RE: Addendum No. 2 – Waller County Bid 25-002 – Construction of Justice Center Vehicle Maintenance Garage

ADDENDUM #2 July 25, 2025

**Waller County - Vehicle Maintenance Garage 200 Sheriff R Glenn Smith Dr.
Hempstead, TX 77445**

S3.21

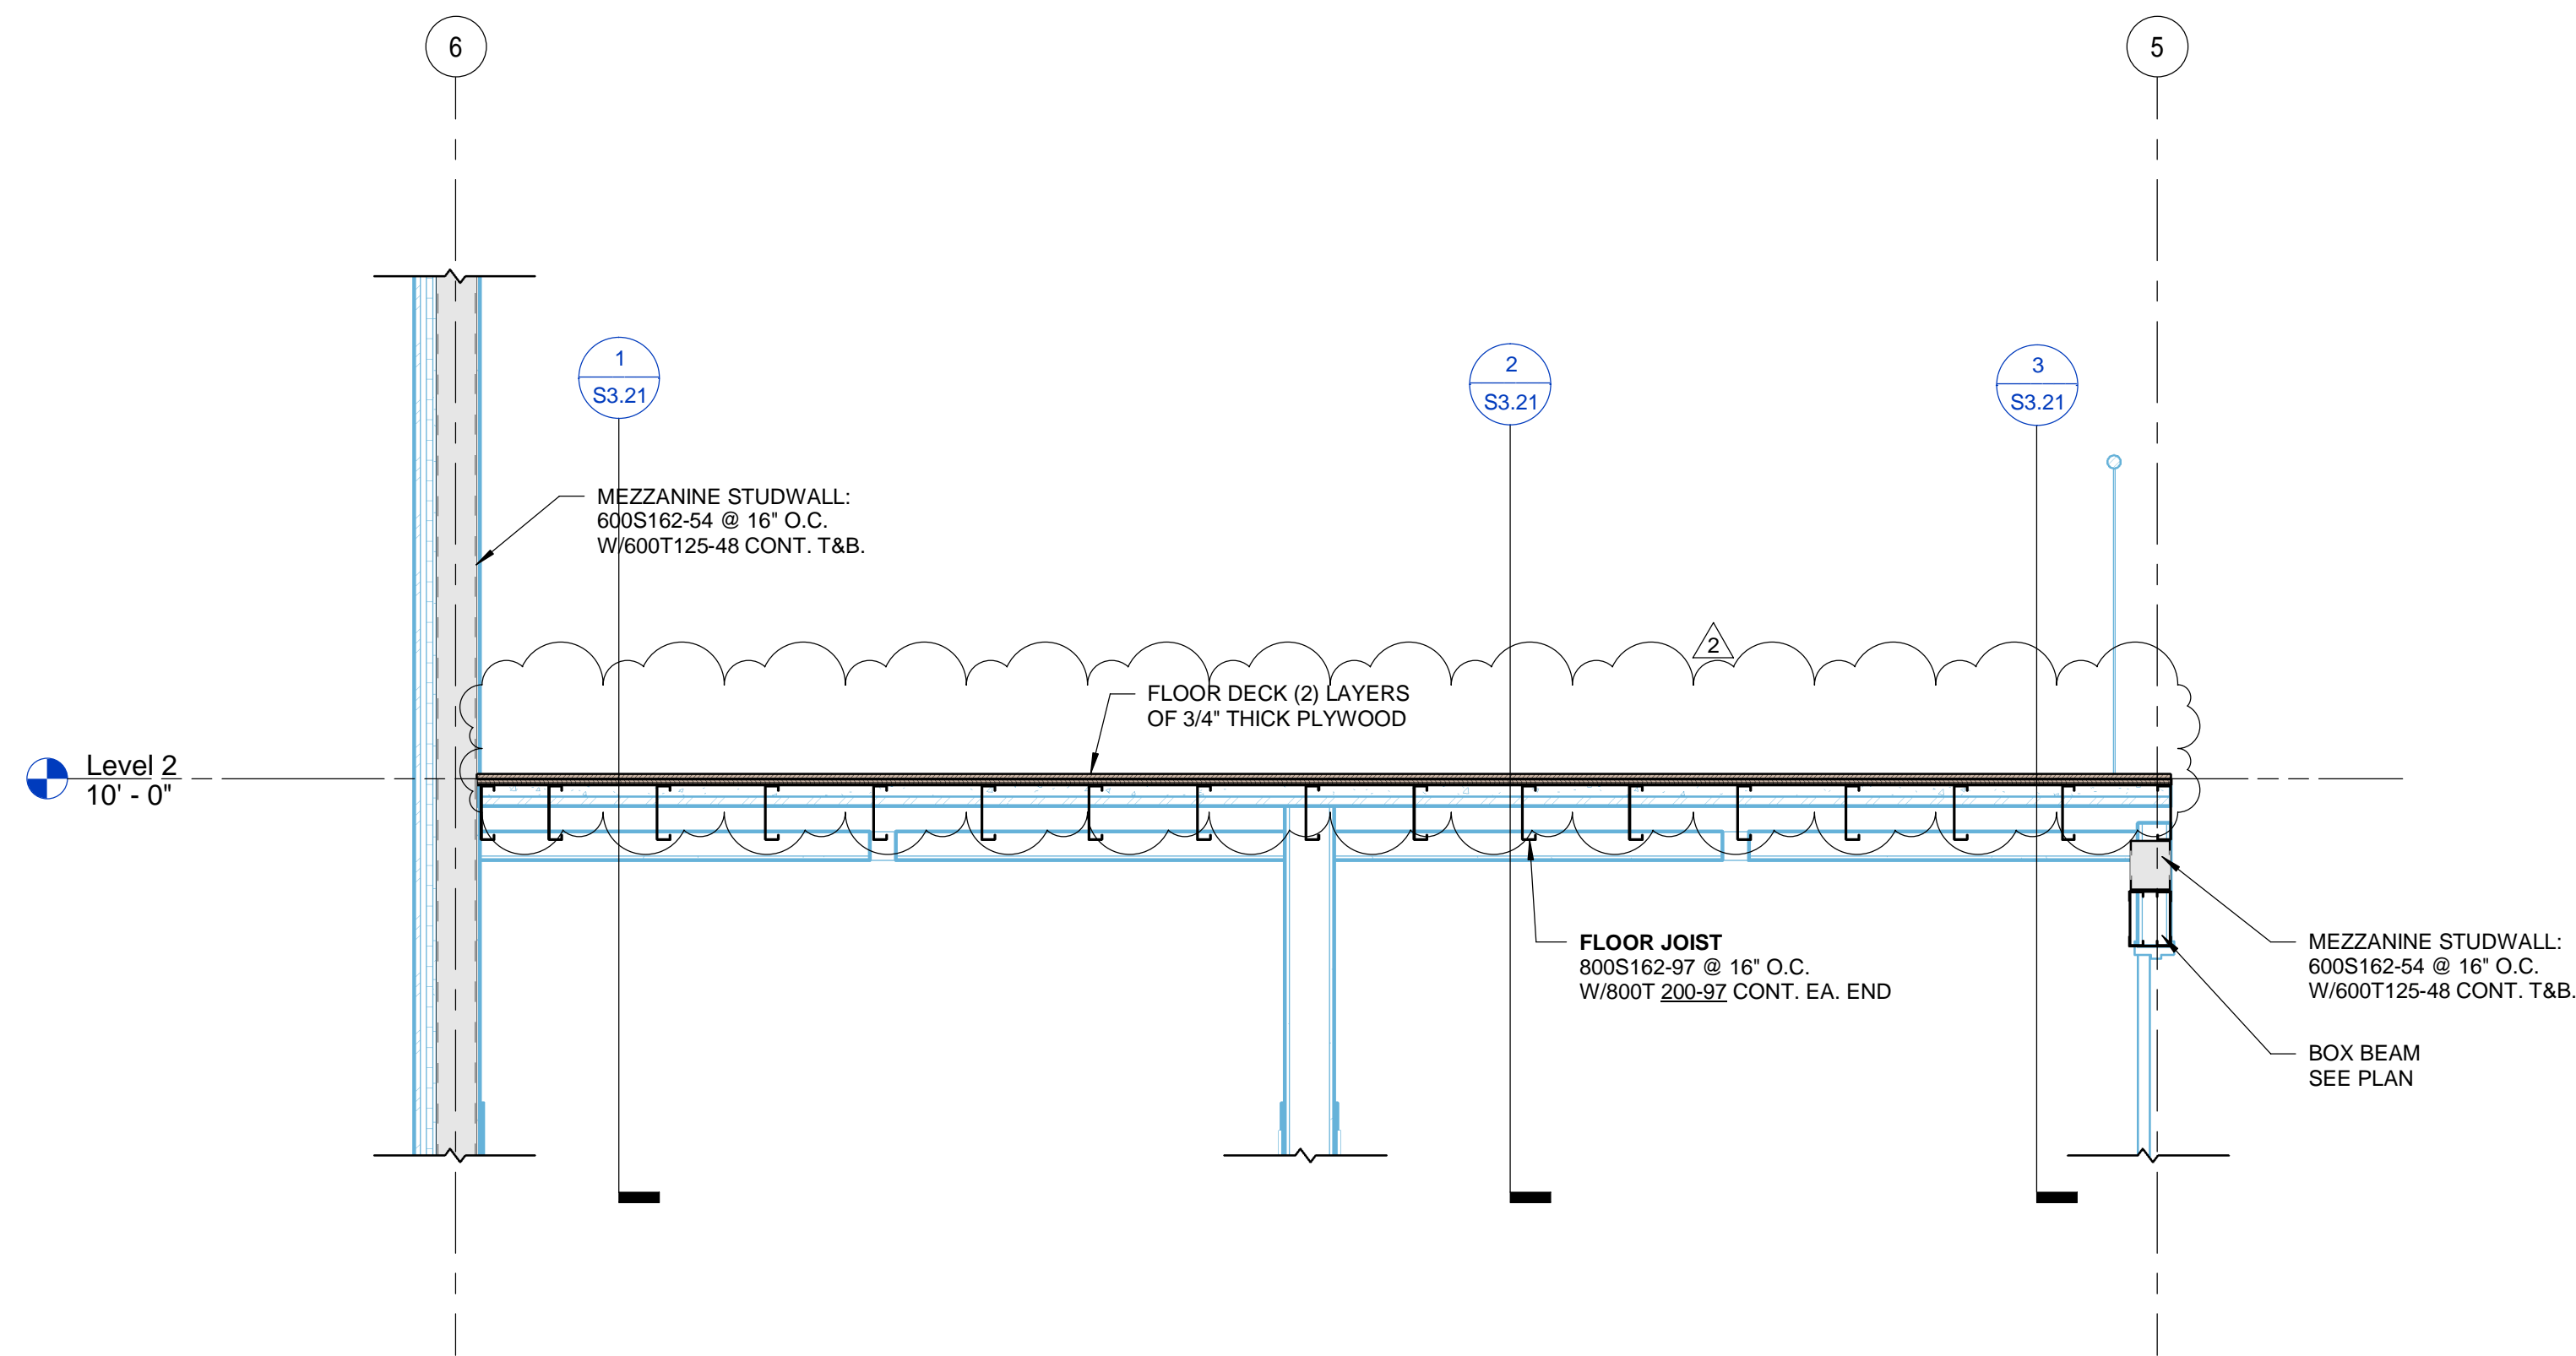
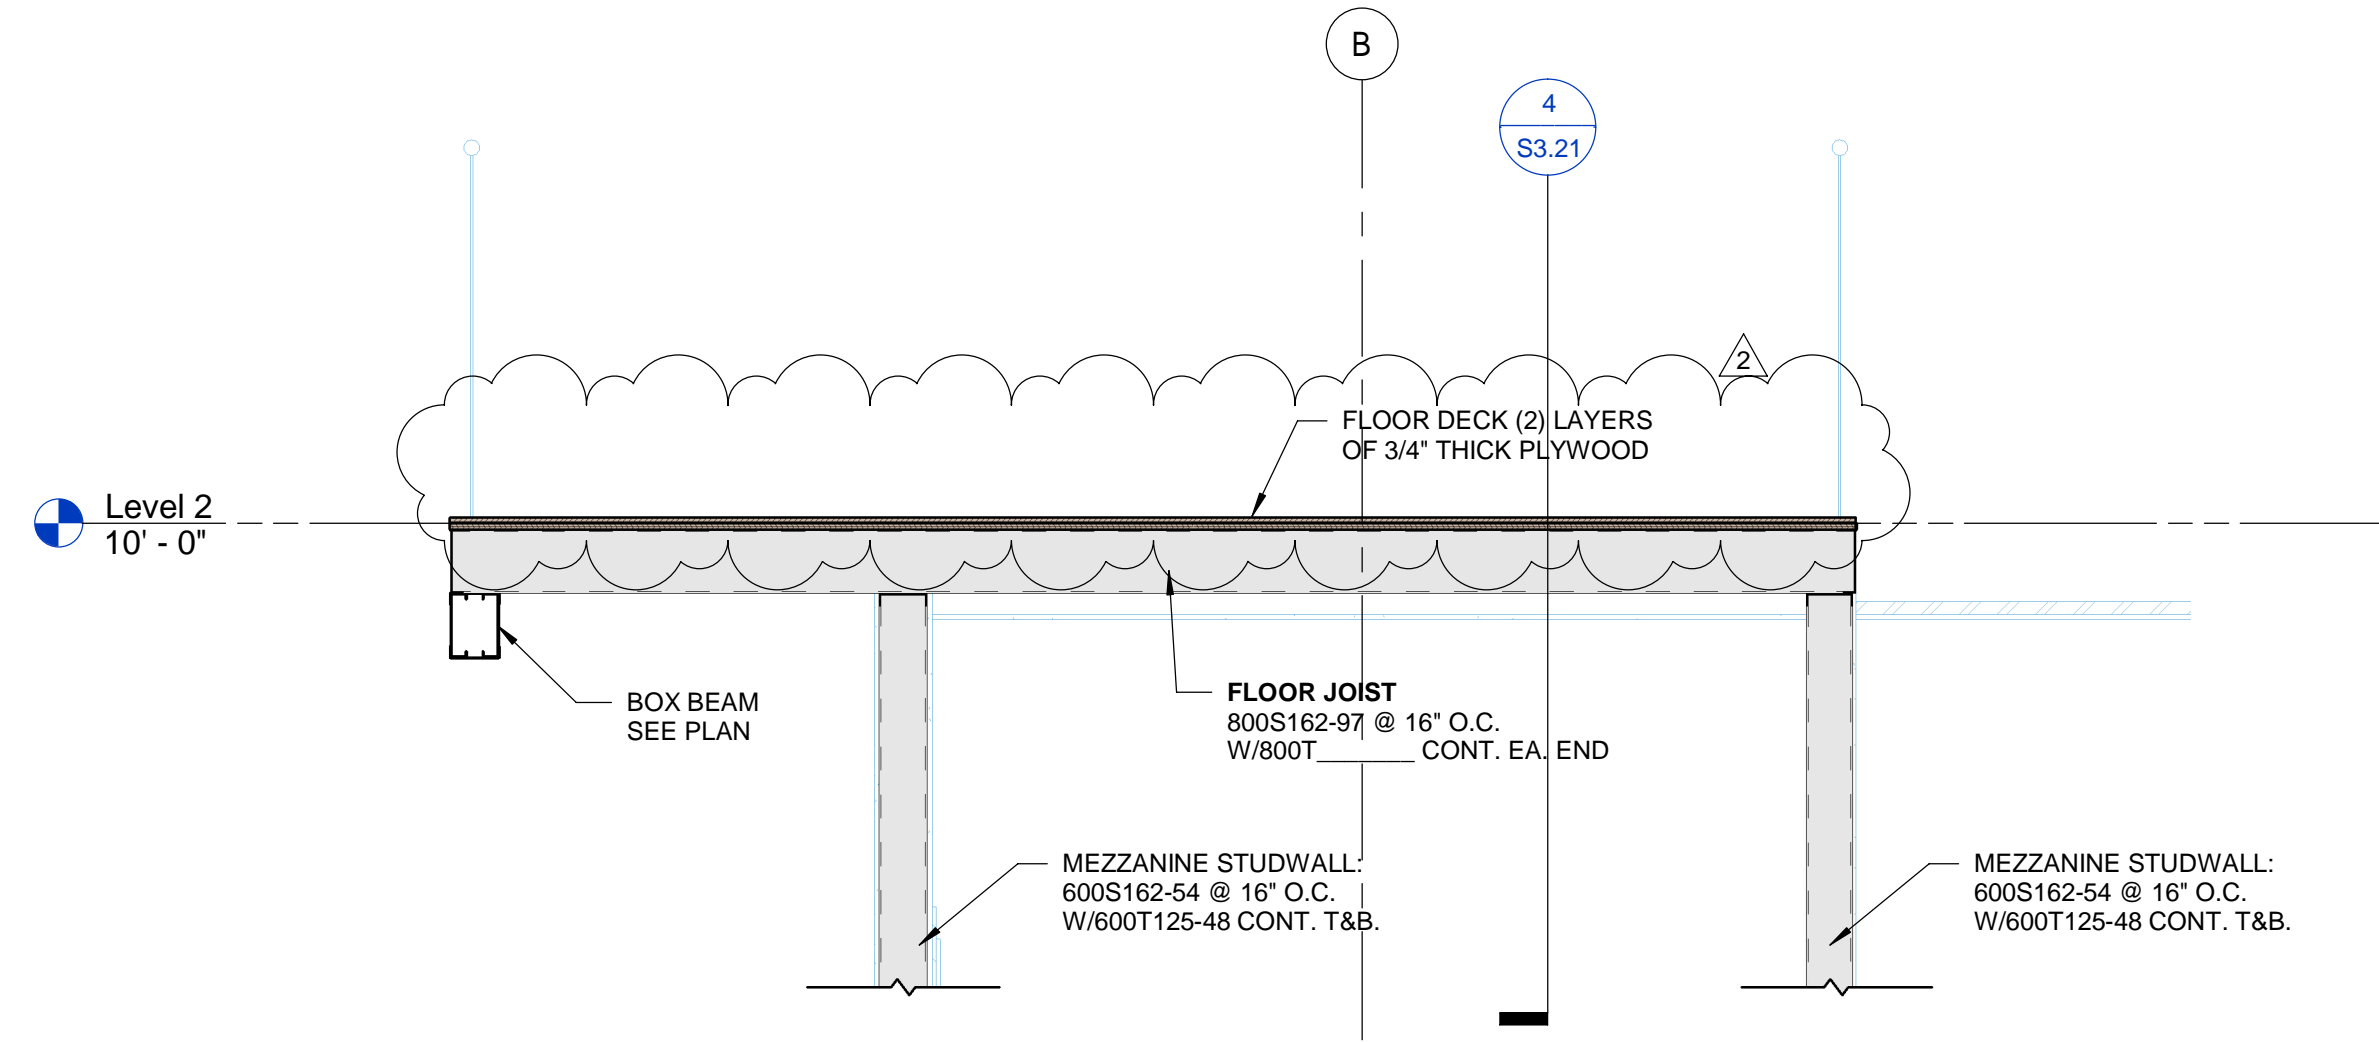
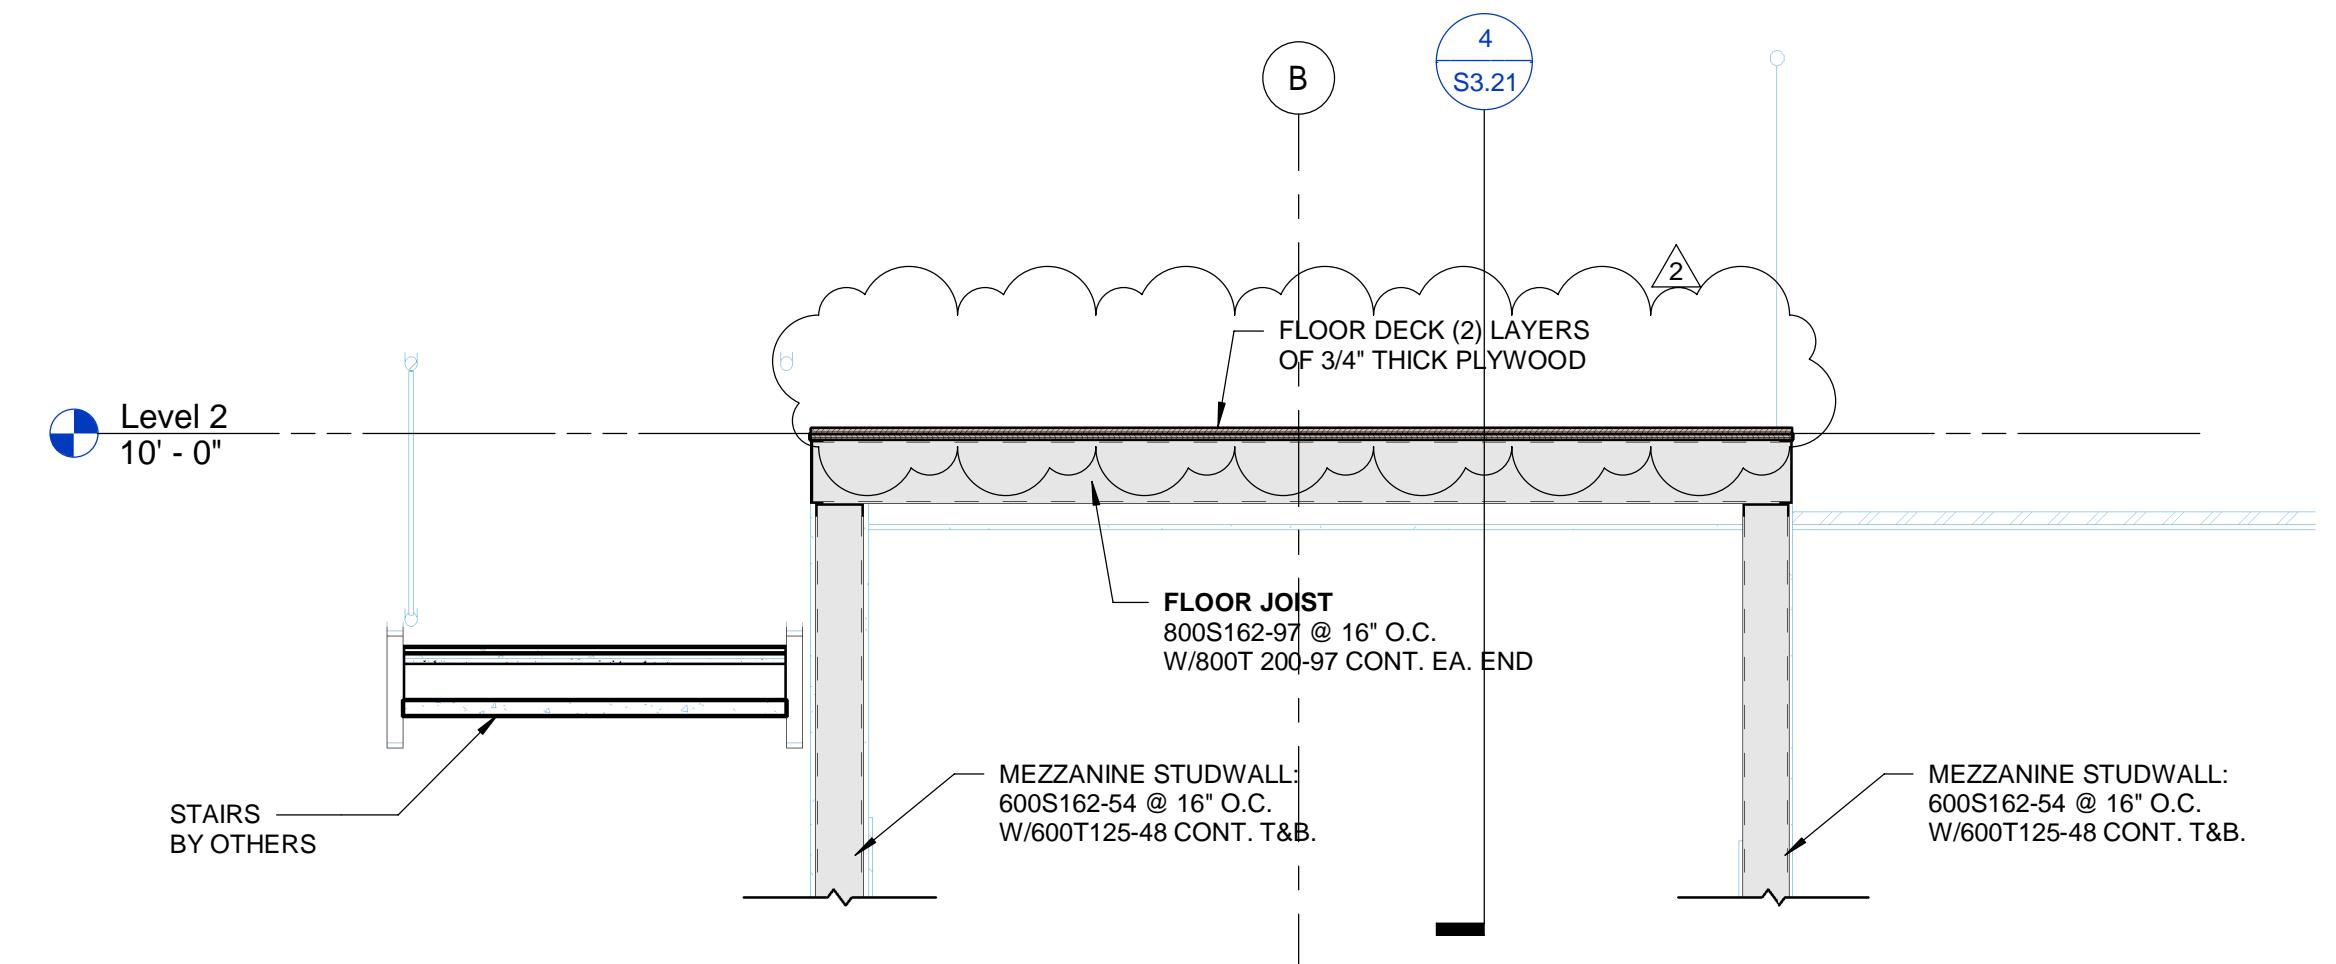
- 1. ... Mezzanine... thickness not shown- please clarify.**

1. Sheet S1-10 – Added slab notes. Added a 2nd layer of floor sheathing to the mezzanine level.
2. Sheet S3.21 - Added a 2nd layer of floor sheathing to the mezzanine level on details 1 -
